N8940A-02

Modification Recommended Service Note

N8940A Autoranging System DC Power Supply

Serial Numbers: DE22350000 to DE23089999

Figure 1: Stuck Keypad

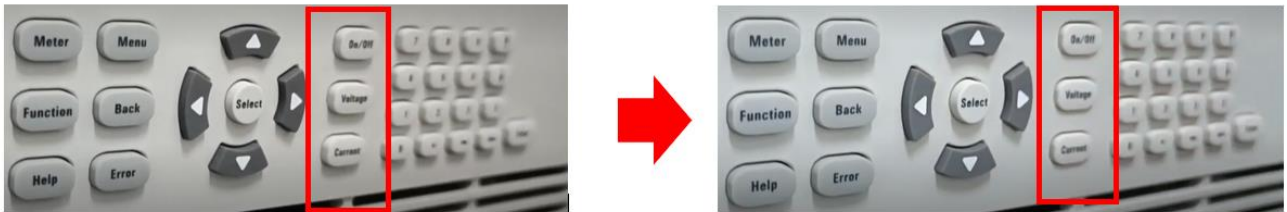
Unit in the above serial number range may intermittently encounter keypad stuck when pressing the keys at front panel. Figure 1 shows an example of a stuck keypad, which could occur with any of the keys.

Kindly contact Keysight Technologies Customer Contact Center at www.keysight.com/find/contactus for sending the affected unit back.
